## 1 ADDENDUM #1

Project Title:  
**Queen Elizabeth Hospital  
 Mental Health & Addictions  
 Emergency Department &  
 Short Stay Unit**

1 RCP - LEVEL 200 RENO  
A162r 1:100

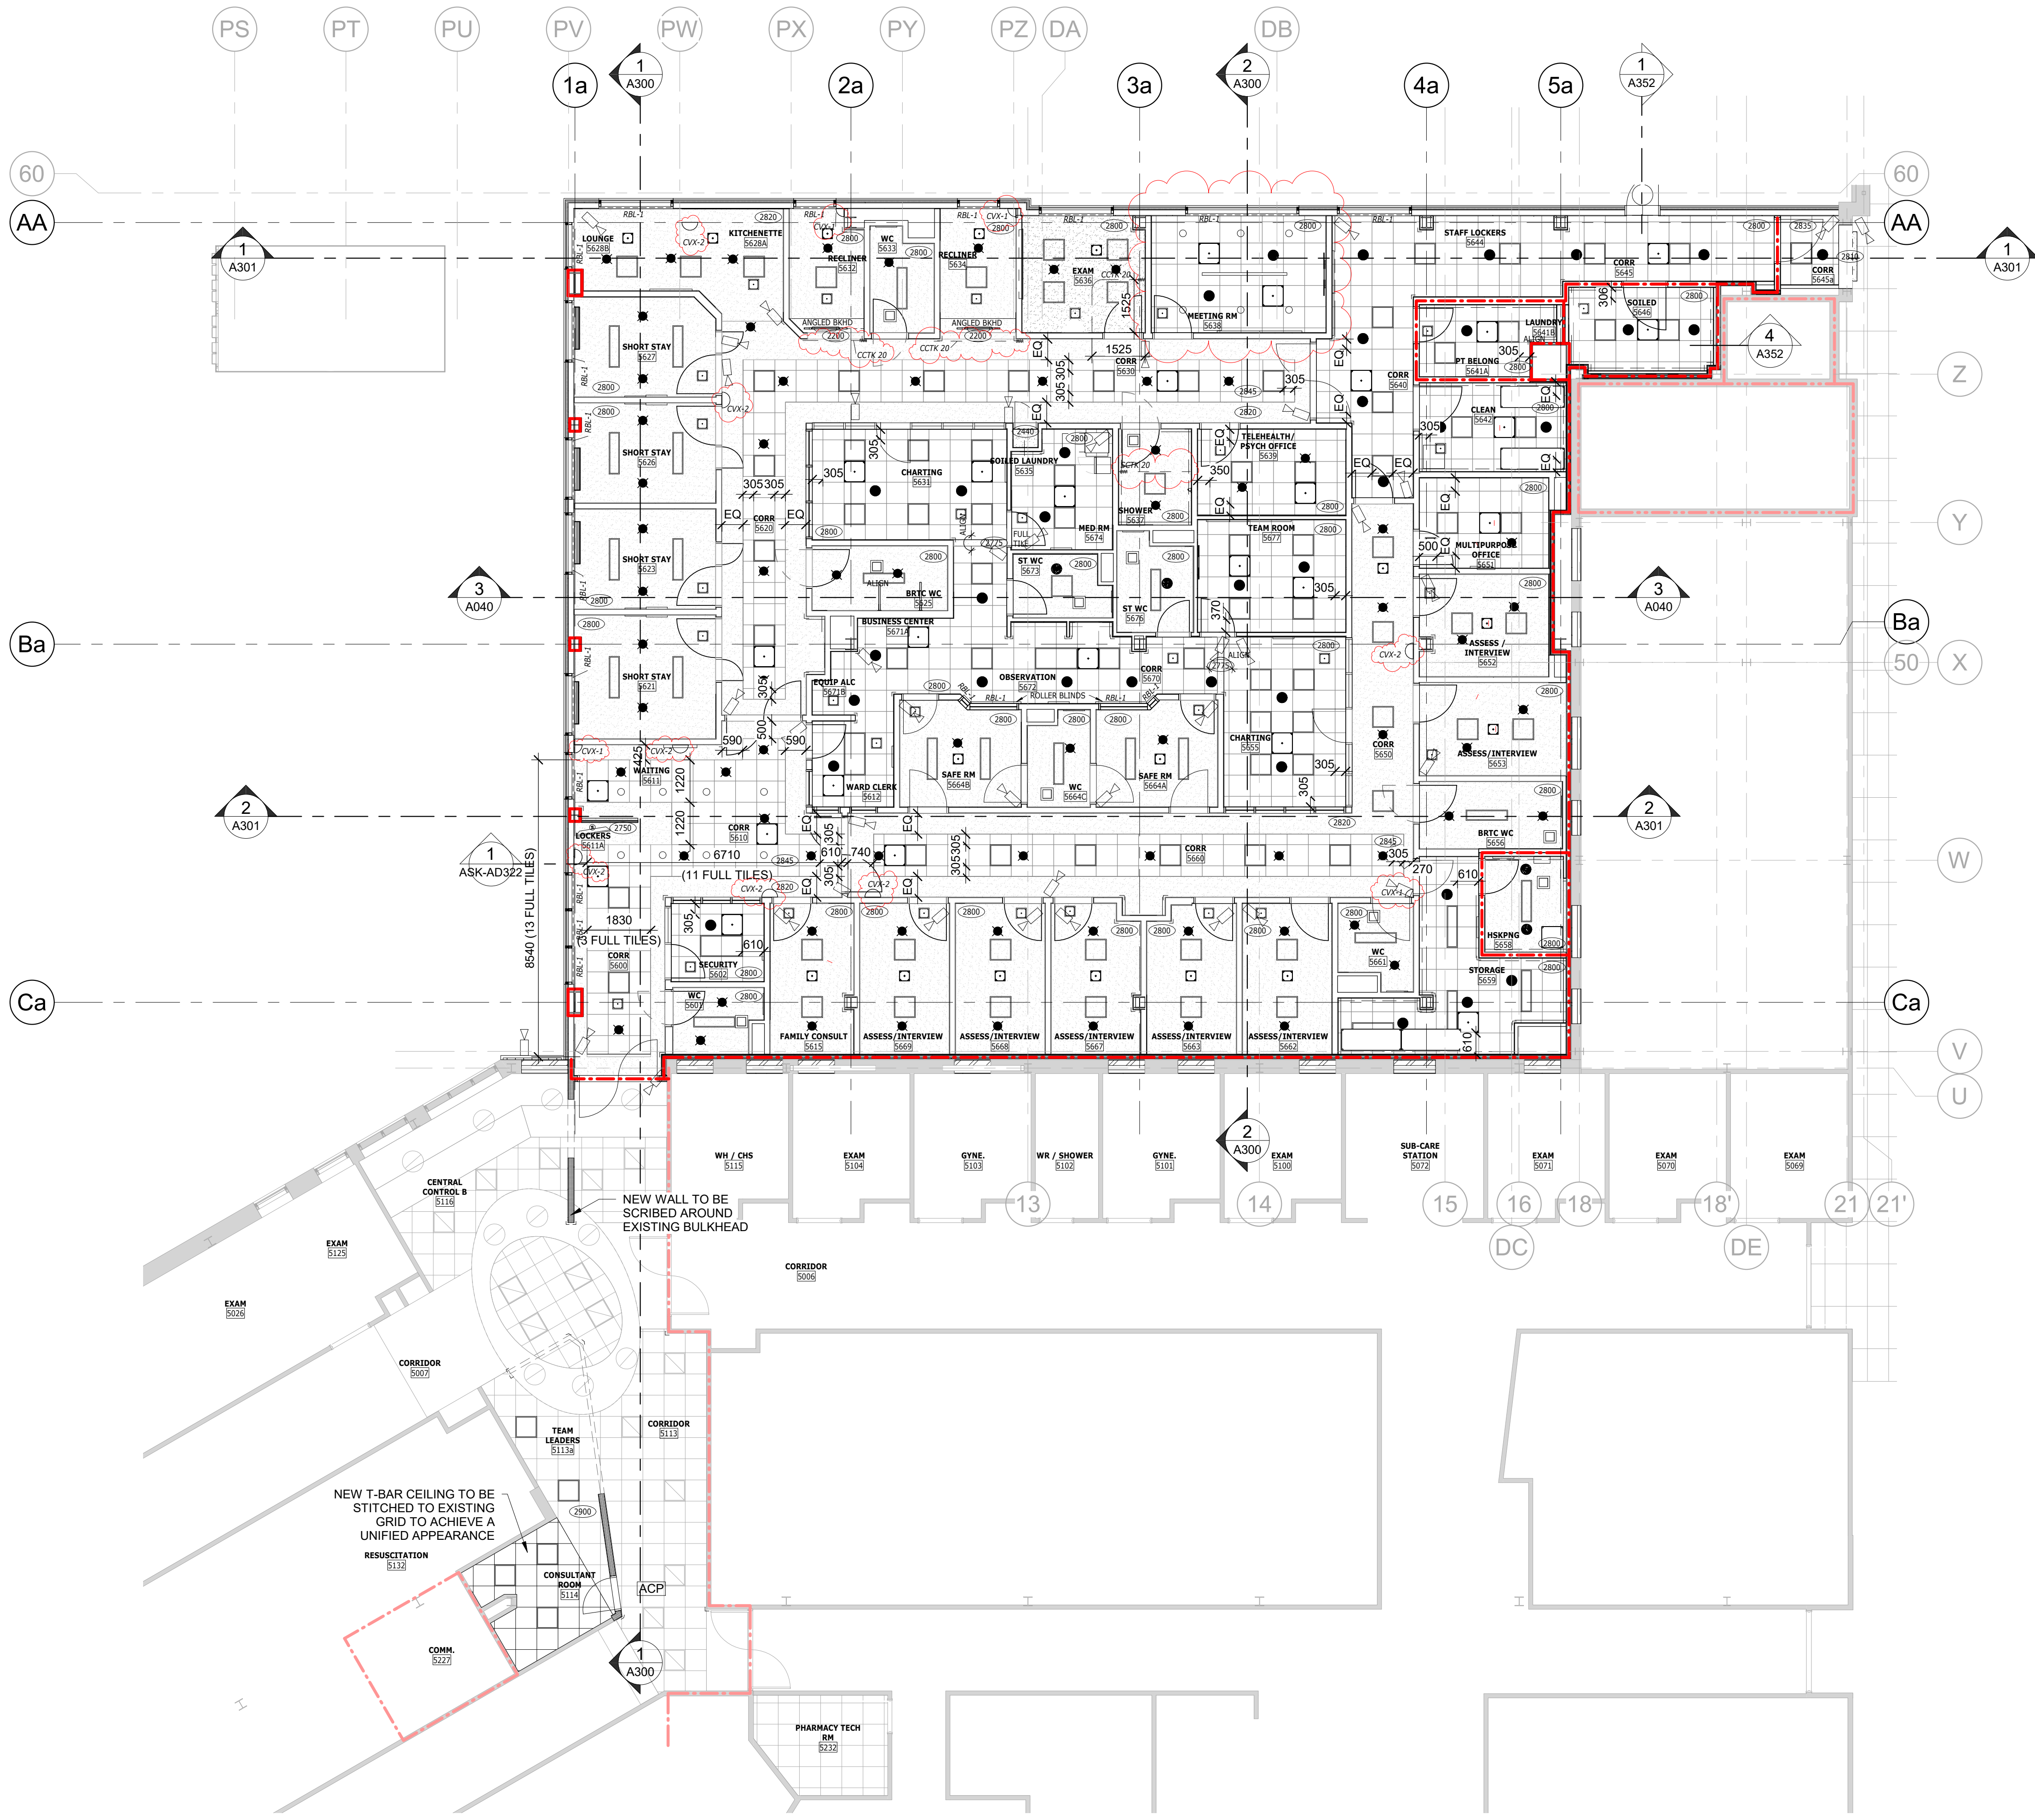
- .5 Reference Drawing A162 – Reflected Ceiling Plan – Level 200 Reno:
    - .1 Delete drawing as originally issued and replaced with revised Drawing A162r1 – Reflected Ceiling Plan – Level 200 Reno - dated March 30, 2022, attached and forming part of this addendum.

**4a TELEHEALTH 5639**  
1:50

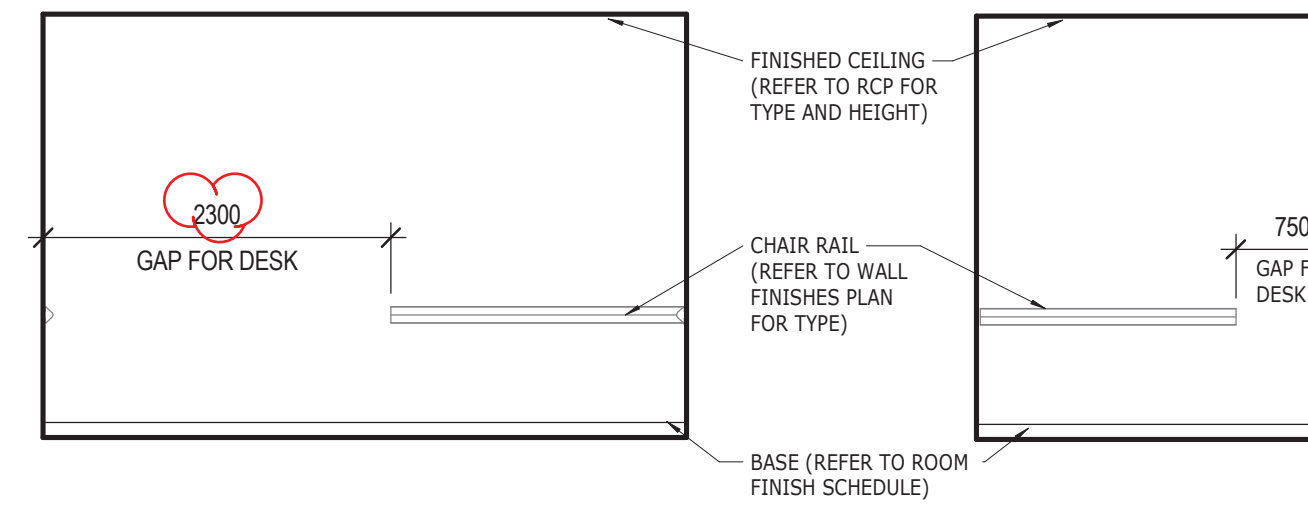
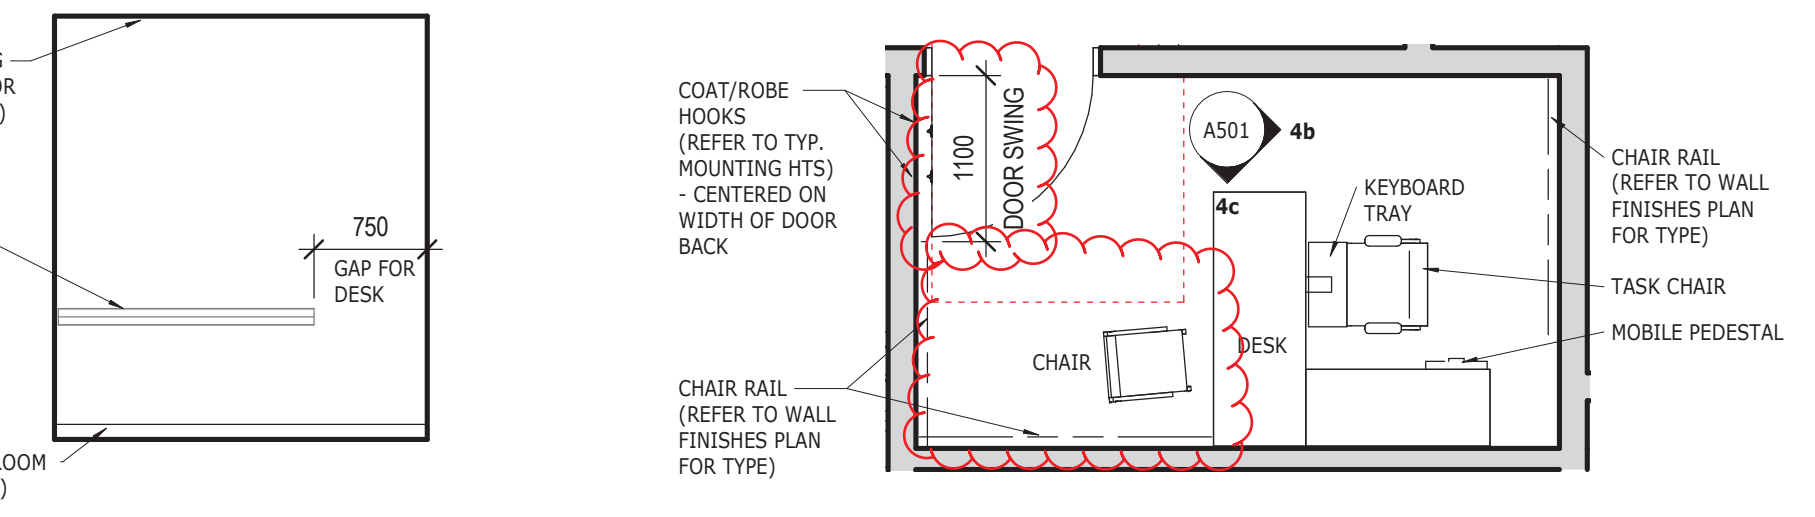
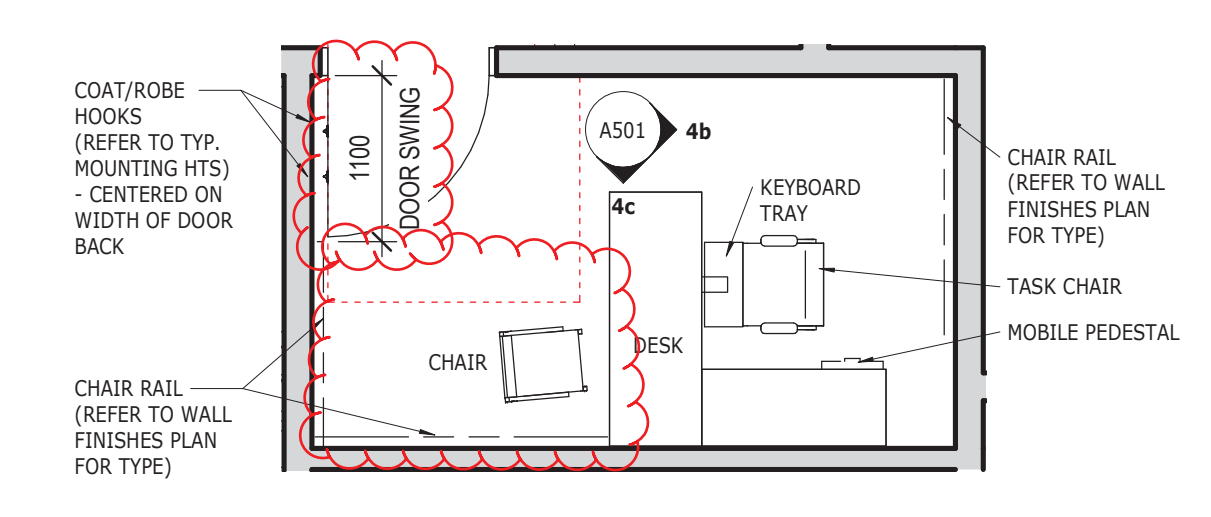
- .14 Reference Drawing E300 – Renovated Floor Plan Level 200 - Power:
- .1 Reference Detail 1/E300:
    - In Telehealth/Psych Office 5639, the duplex receptacle located on the north wall behind the television at 1800mm AFF is to be relocated to the south east corner of the room and be recess mounted at 450mm AFF.

- .2 In Telehealth/Psych Office 5639, delete the HDMI and communications outlet located at 1800mm AFF on the north wall, the HDMI outlet located on the west wall and all associated conduit back to source.

**4a TEAM ROOM 5677**  
1:50

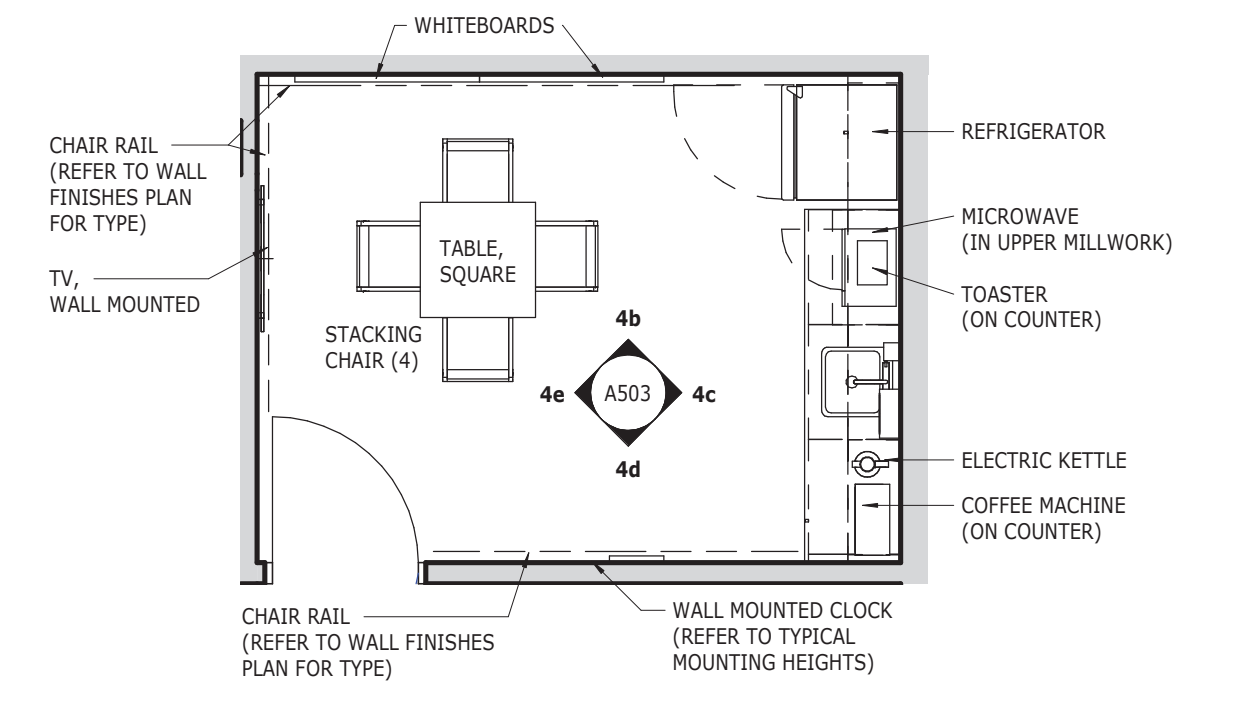
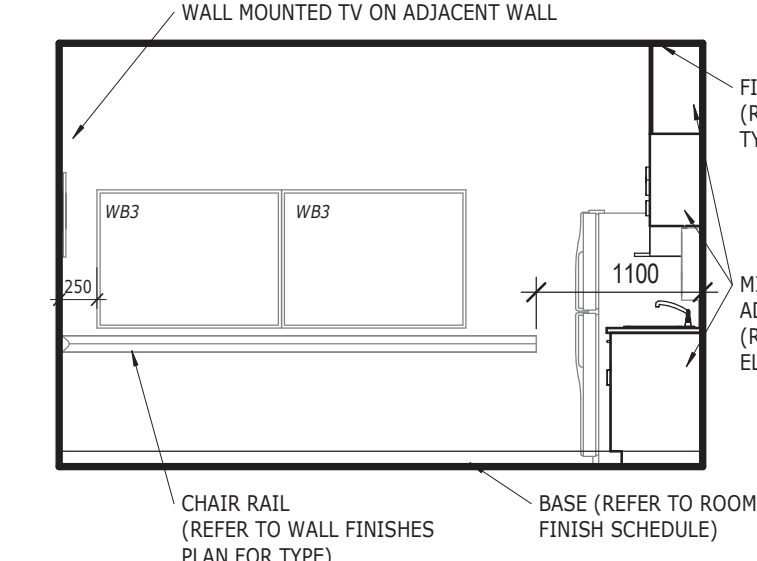
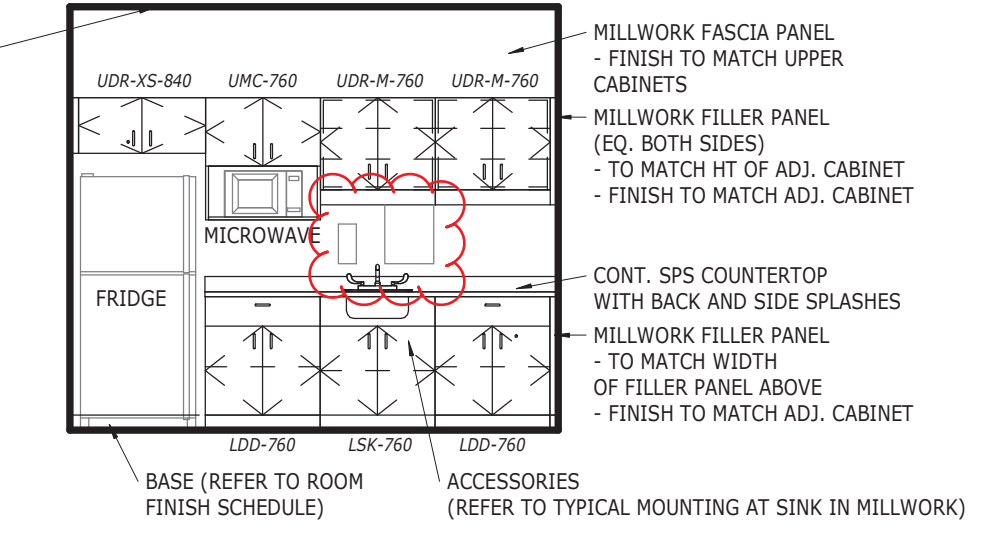
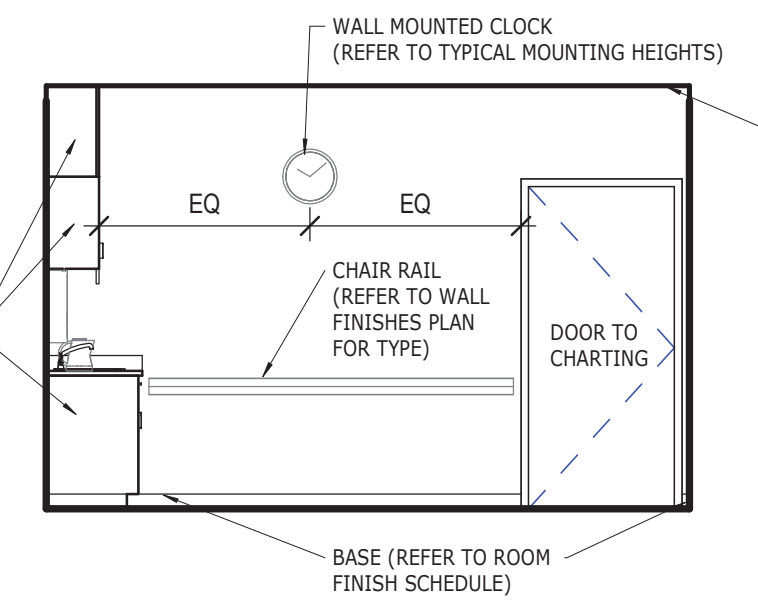
NOTE: PROVIDE LOCKS FOR ALL MILLWORK DOOR SETS AND DRAWERS.

**2a MED RM 5674**  
1:50

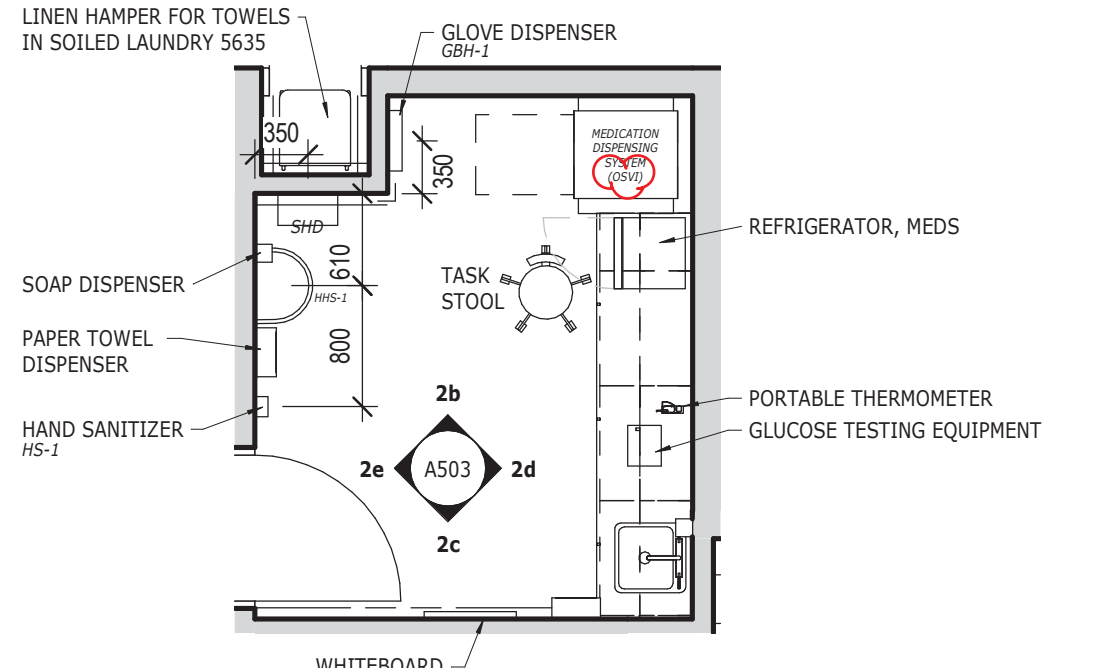
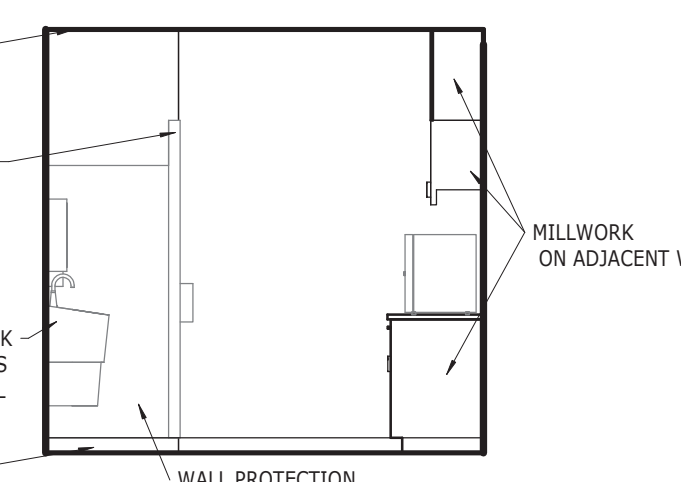
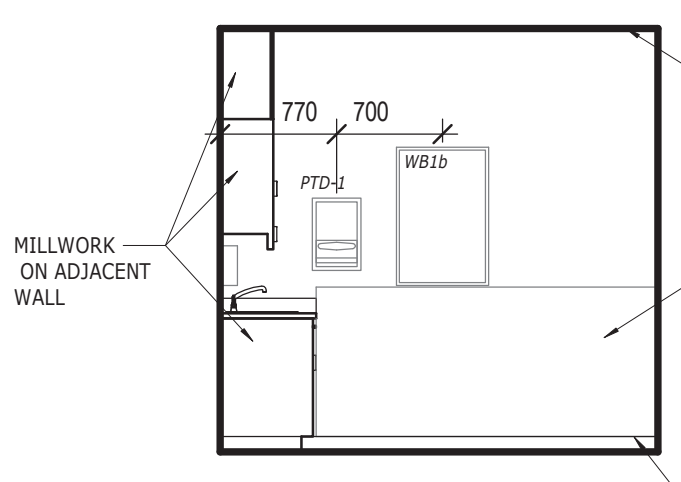
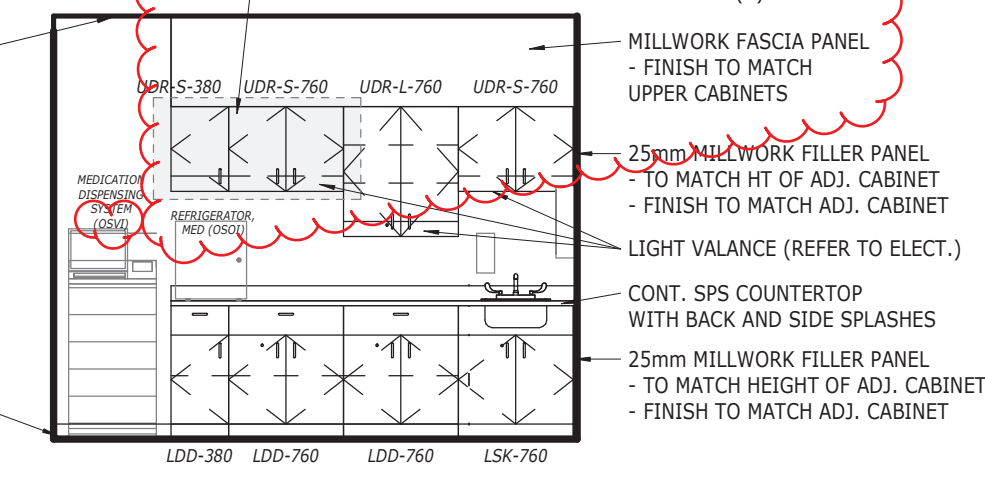
NOTE: PROVIDE LOCKS FOR ALL MILLWORK DOOR SETS AND DRAWERS.
